ENGINE TEST PROGRAM

MEMORANDUM FOR THE RECORD

SUBJECT : Headquarters 4070th Support Wing letter dated 9 January 1956
re "Aircraft and Equipment Problem Areas - Project AQUATONE

AIRFRAME VS. EQUIPMENT SUMMARY AS OF**12-8-55**

TACTICAL COMBINATIONS

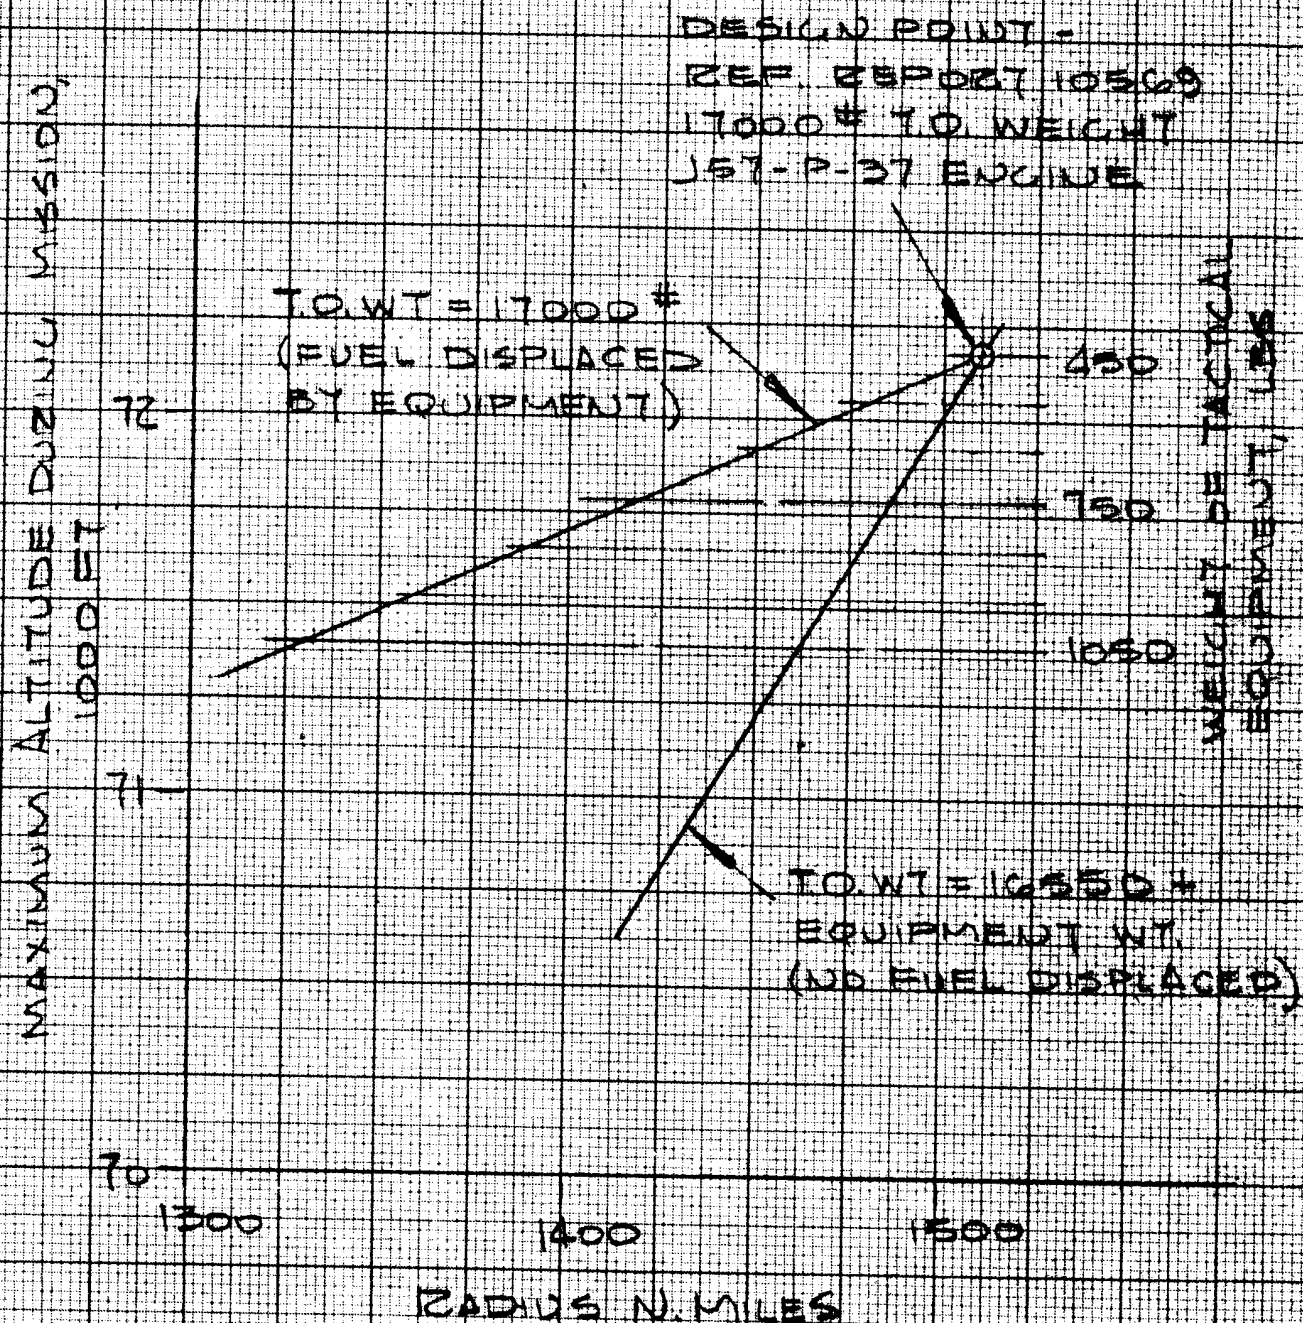
The tactical combinations which may be achieved by use of the various equipments is indicated in Fig. 1 where, for simplicity, only five representative types have been considered. Notice that there is a basic difference occurring with aircraft 349 which permits the use of Systems III and IV, and APQ56. These equipments cannot be installed on aircraft 341 thru 348.

FIGURE 4

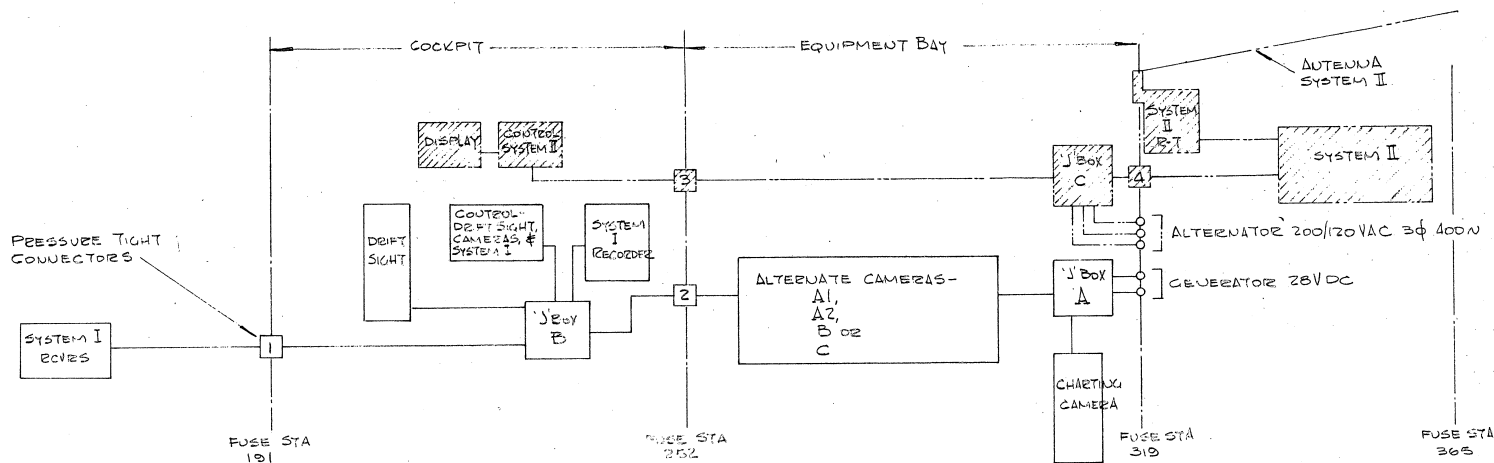
NOTE -
 AIRCRAFT 341 THRU 348 WILL ACCOMMODATE THIS ARRANGEMENT AS FOLLOWS -
 1. THE PRESENT AIRCRAFT 341 THRU 348 PROVIDE FOR THE CAMERA, DEPT SIGHT & SYSTEM I INSTALLATIONS.
 2. THESE AIRCRAFT REQUIRE THE MODIFICATIONS SHOWN AS [Hatched Box] TO INSTALL SYSTEM II.
 3. AIRCRAFT 345 & UP WILL HAVE THE 3φ ALTERNATOR INSTALLED. AIRCRAFT 341 THRU 344 WILL BE MODIFIED AS REQUIRED.

FIGURE 5

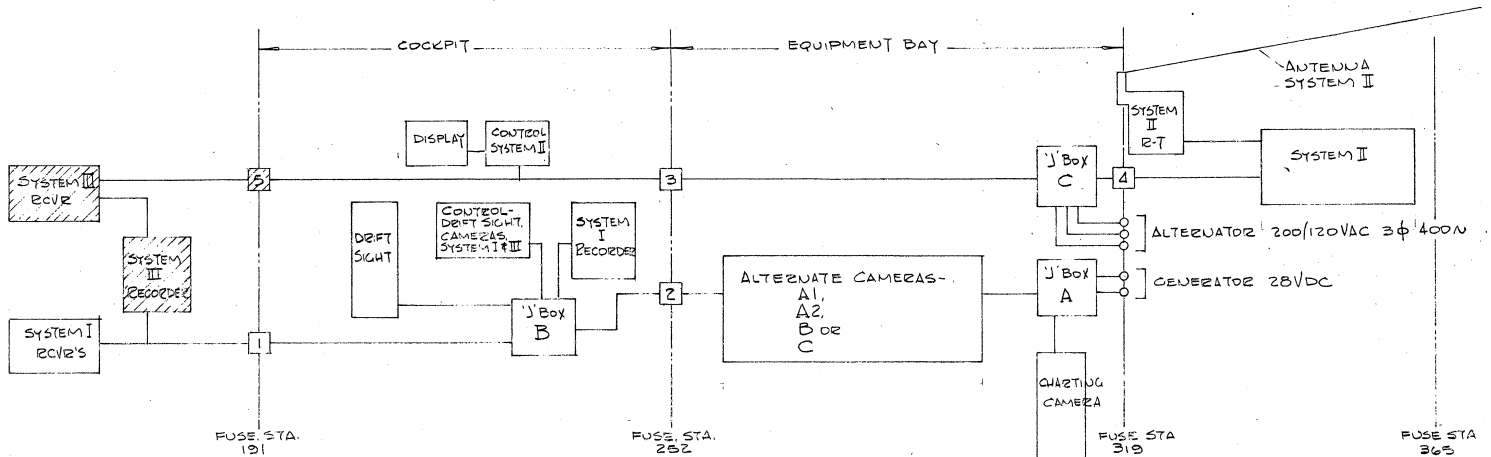
NOTE -
 AIRCRAFT 349 THRU 360 WILL ACCOMMODATE THIS
 ARRANGEMENT.
 1. THESE AIRCRAFT WILL HAVE ALL BASIC CHANGES INCORP-
 ORATED FOR INSTALLING THE ABOVE OR OTHER PRESENTLY
 PLANNED EQUIPMENT.
 2. THE EQUIPMENT ADDITIONS ARE INDICATED AS .

FIGURE 7

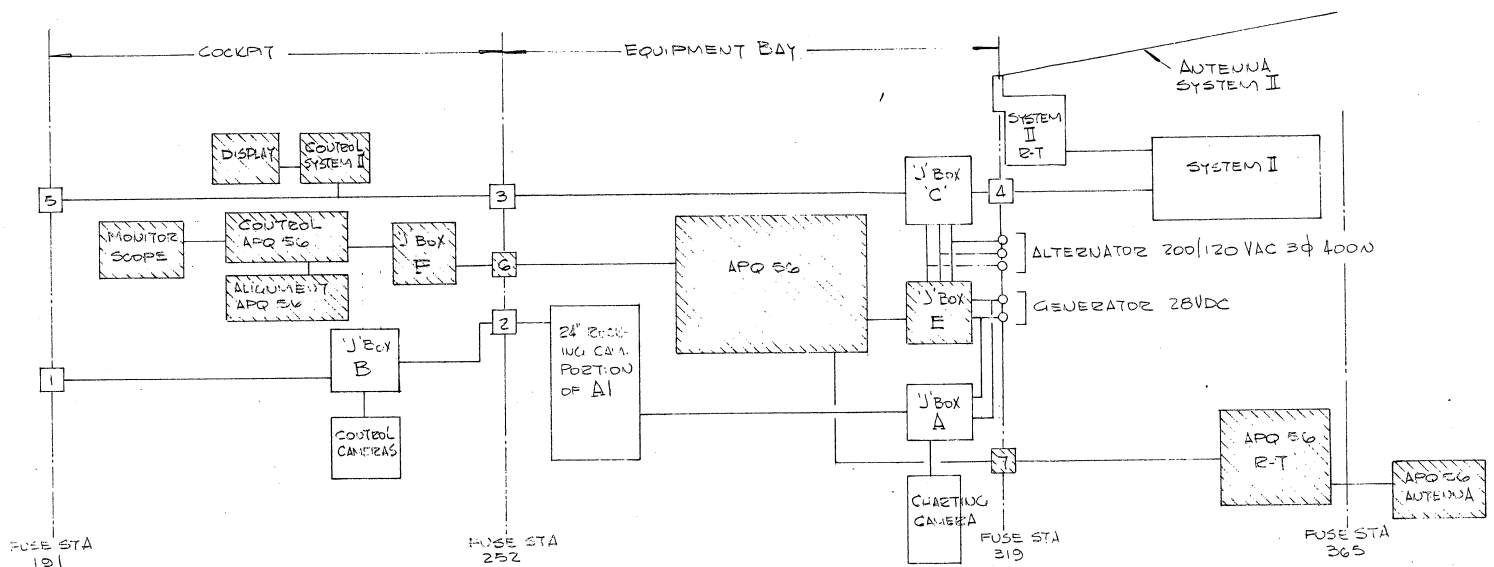
NOTE -
 AIRCRAFT 349 THRU 360 WILL ACCOMMODATE THIS
 ARRANGEMENT
 1. THE APQ 56 ADDITIONS ARE NOTED BY 
 2. PART OF A1 CAMERA EQUIPMENT CAN BE USED
 CONCURRENTLY.
